PO Change Order Request Form

Change Order

Project: **Roosevelt Modular Classrooms**
951 Dowling Ave.
San Leandro, CA 94577

CO #: 9
Date: 04/20/2021
Contract Date: 02/05/2020
DSA Application #: 01-118101
DSA File #: 01-35

CEI - 12.15.20

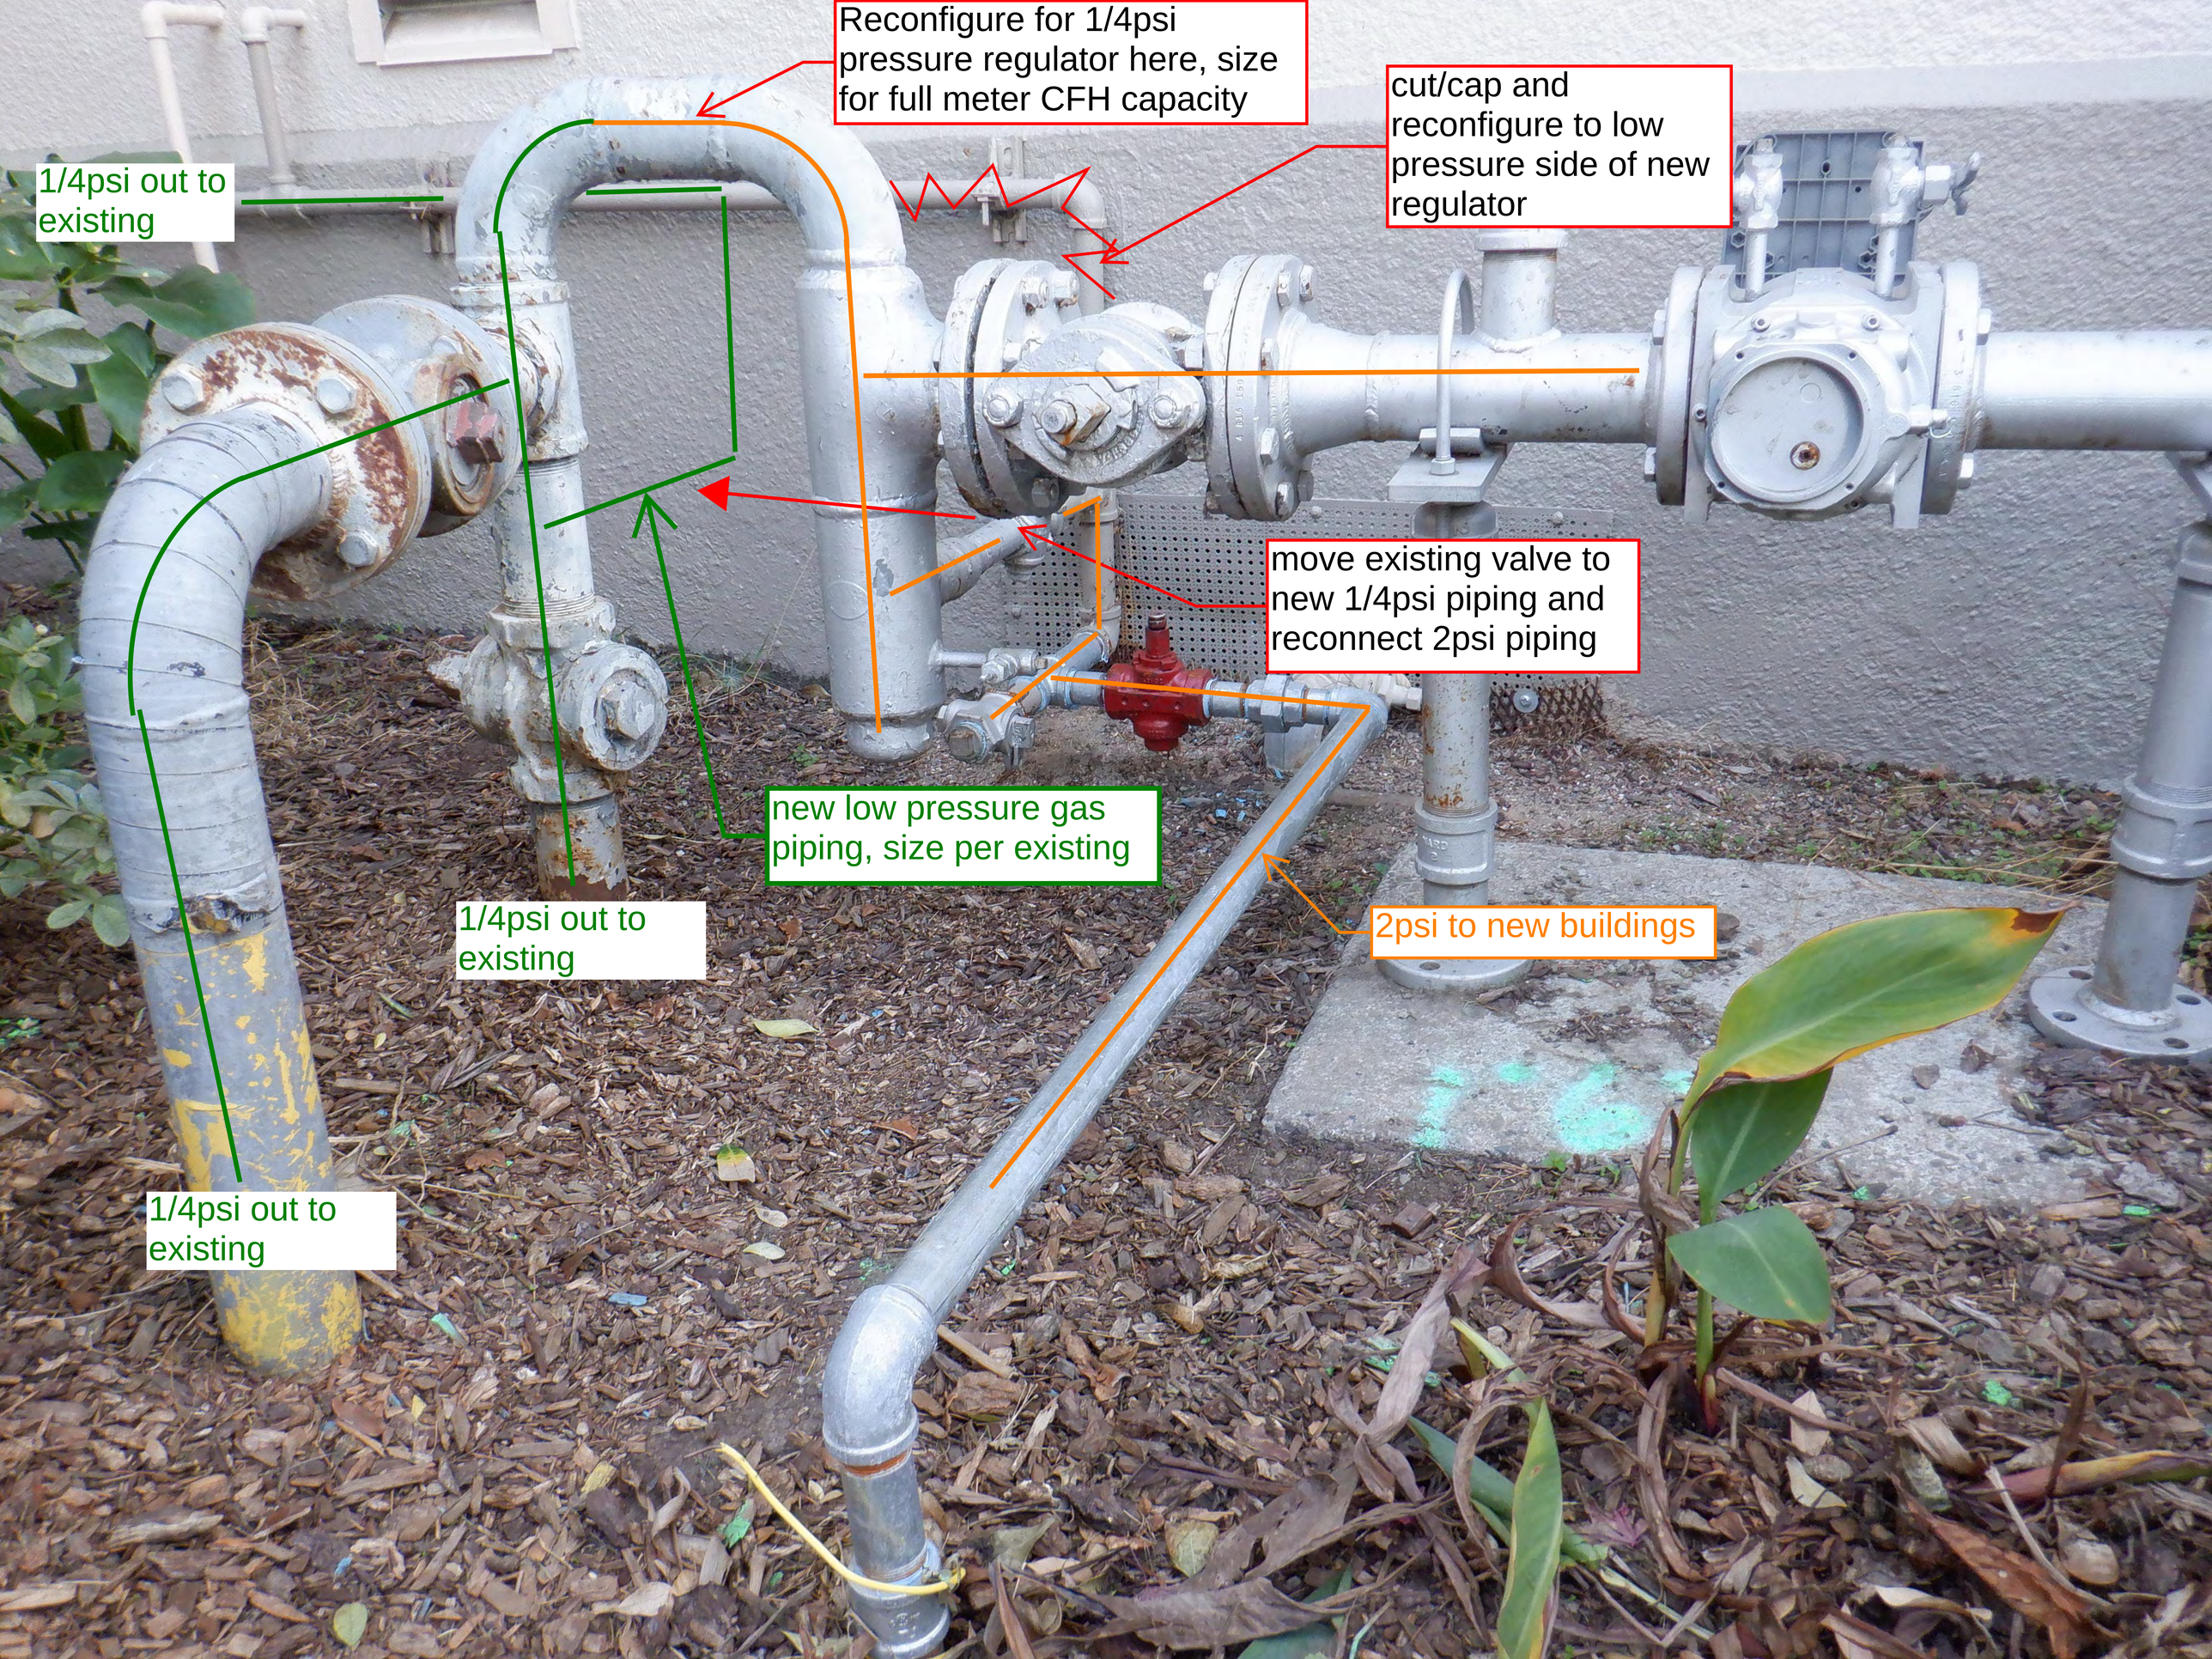
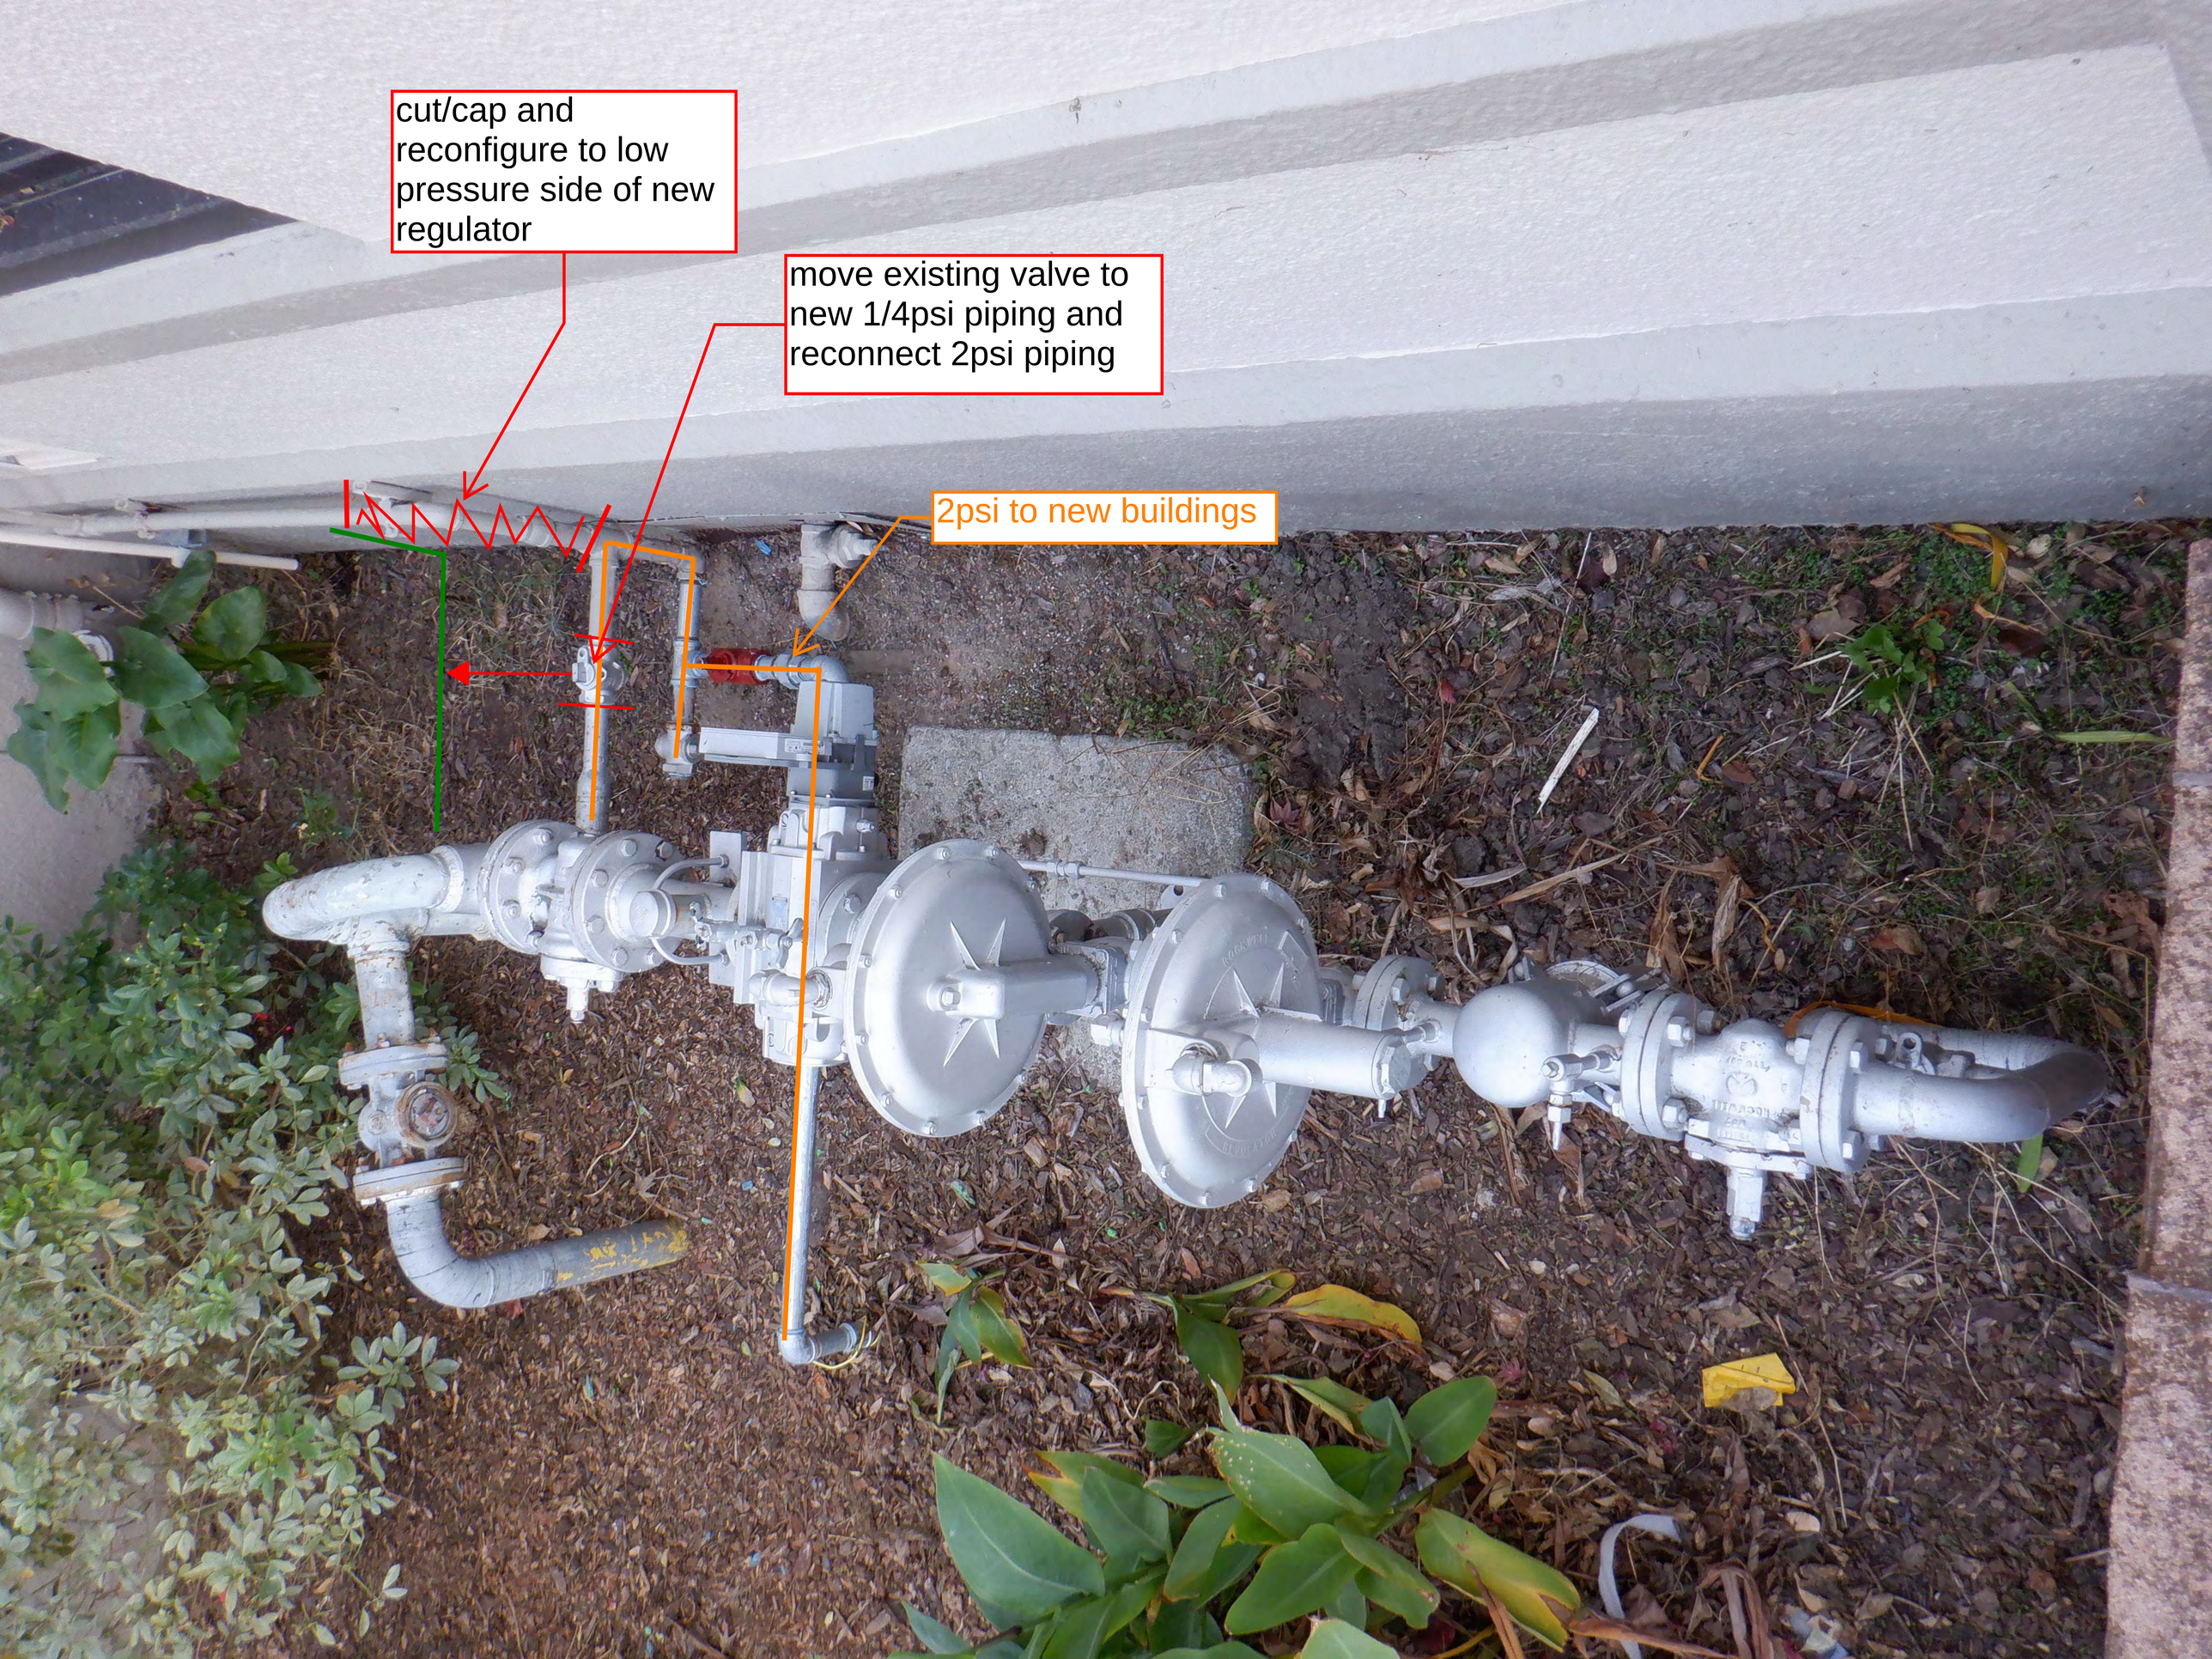
PG&E will be upping the gas pressure at the existing gas manifold to 2 PSI to allow for proper gas pressure at the new buildings. JLC would like to "T" on the Districts side of the meter. One side of the "T" will have a regulator installed on it to provide 1/4 PSI to the existing campus. The other side of the "T" will connect to the new underground gas line and provide 2 PSI of gas to the regulators installed at the new buildings.

Please review the attached photos and advise as to which items on the existing gas manifold can be removed/reconfigured to free up some room for the new "T" and regulator.

See sketches below, locate 1/4psi regulator after the T to the new 2psi building connection as indicated. Elbows can be reoriented to fit in new regulator. Size regulator for full CFH meter load. Ensure all relocated return to serve the same gas line as existing configuration.

Reconfigure for 1/4psi pressure regulator here, size for full meter CFH capacity
cut/cap and reconfigure to low pressure side of new regulator
1/4psi out to existing
move existing valve to new 1/4psi piping and reconnect 2psi piping
new low pressure gas piping, size per existing
1/4psi out to existing
2psi to new buildings
1/4psi out to existing
